SYAMA PRASAD MOOKERJEE PORT,KOLKATA
Erstwhile KOLKATA PORT TRUST
HALDIA DOCK COMPLEX

Tender No. SDM (P&E)/T/ 62 /2019-2020

Supply, Installation, Testing and Commissioning of 11kV/3.3kV/415V Panel along with allied works for augmentation of GC Berth Sub-station including construction of sub-station building at GC Berth area of Haldia Dock Complex, SMP, Kolkata.

ADDENDUM - IV

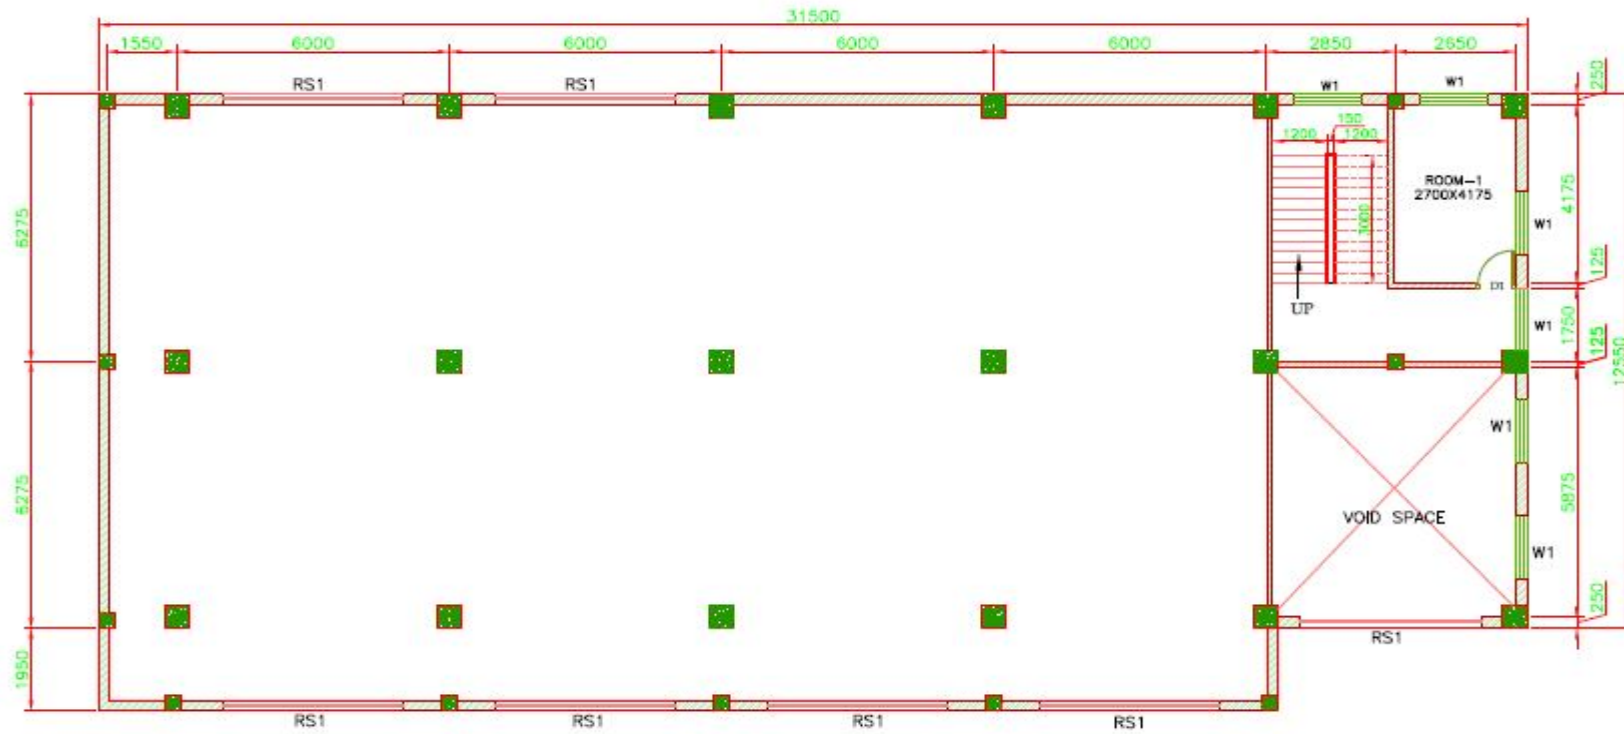
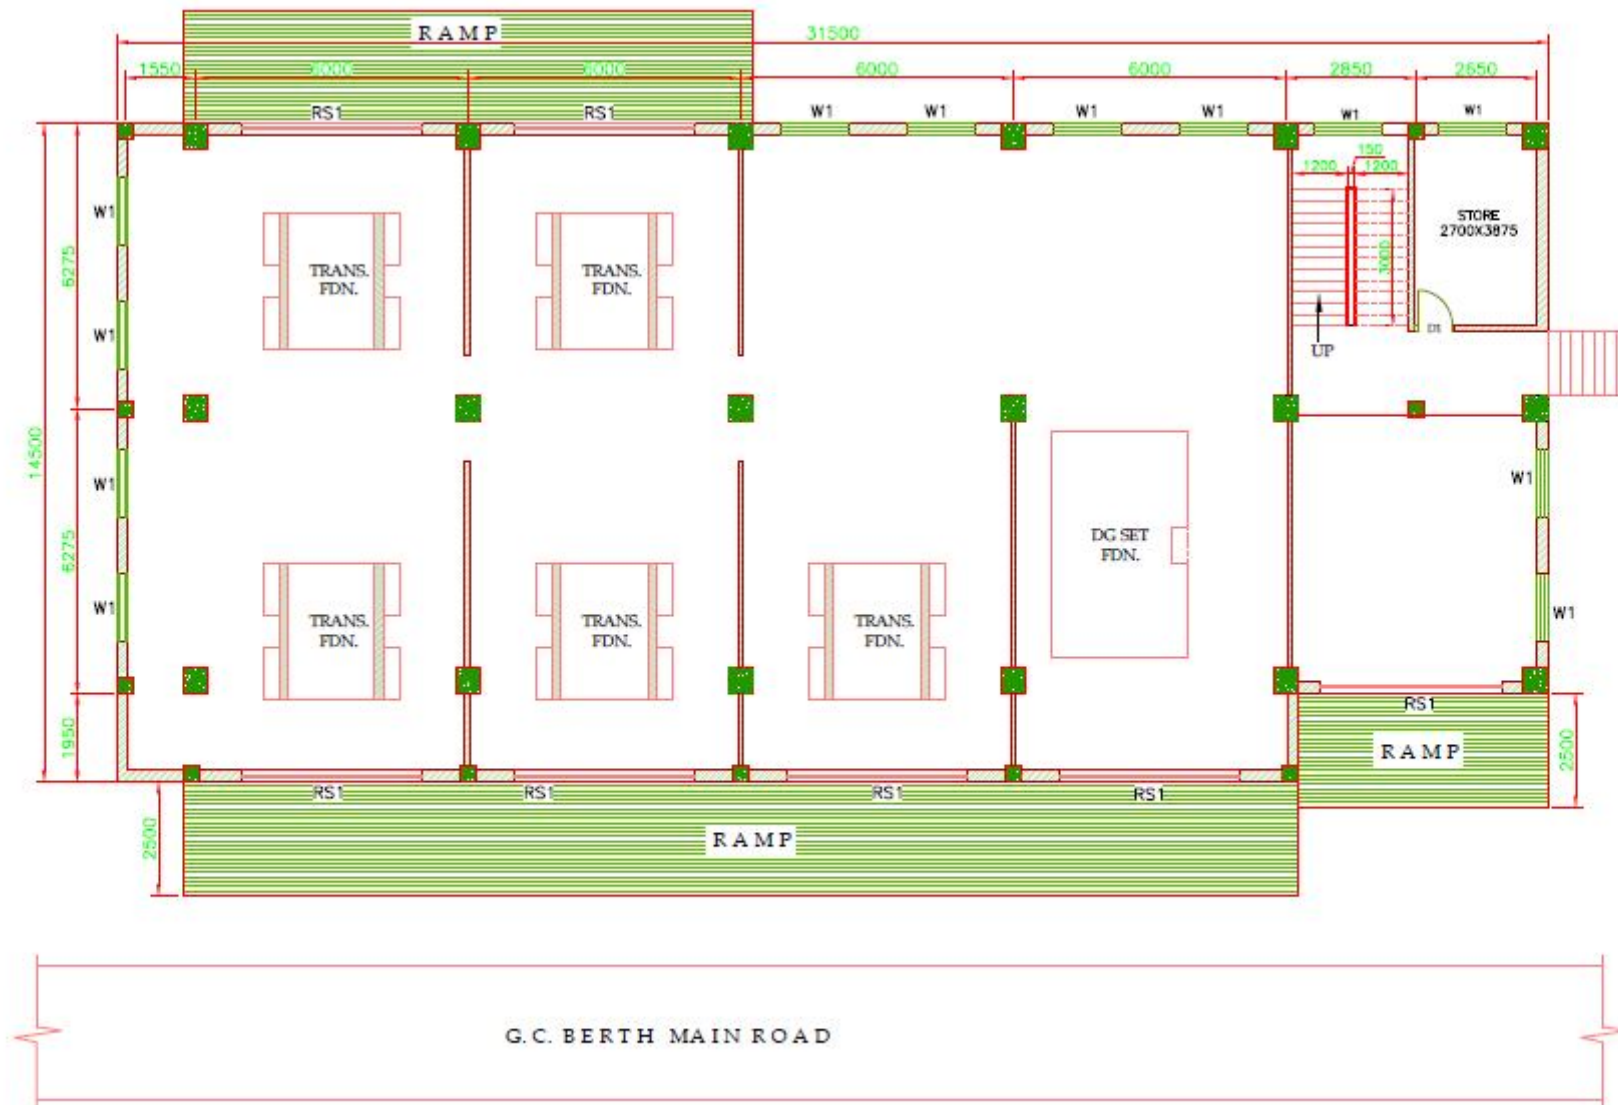
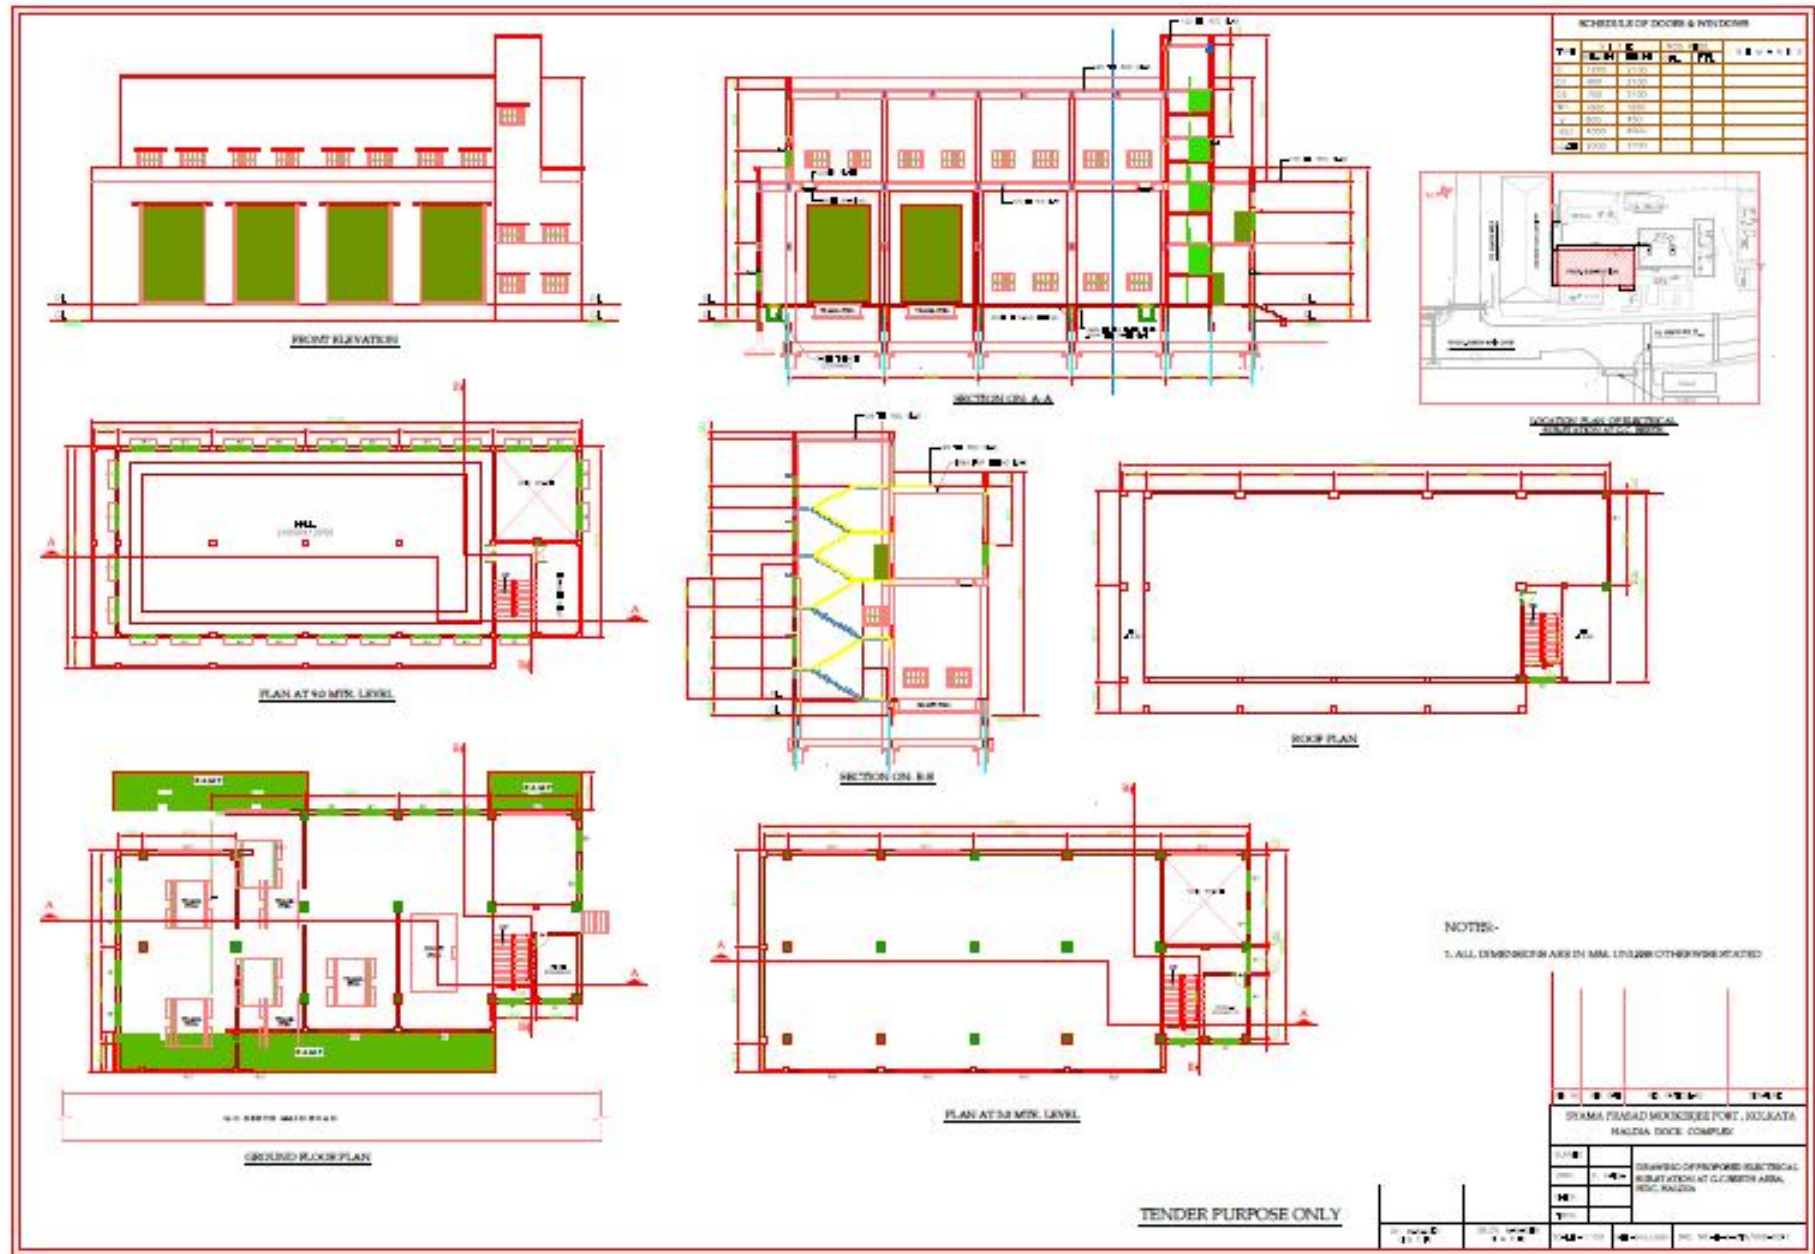
33.	Control Building Civil tender drawing	Control Building Civil tender drawing Civil Tender drawing (Mainly Control Building of GF/5.0/9.0 Meter Plan) not legible. So, we are requesting you please provide the legible documents which help us to provide most competitive bid	Please see addendum.
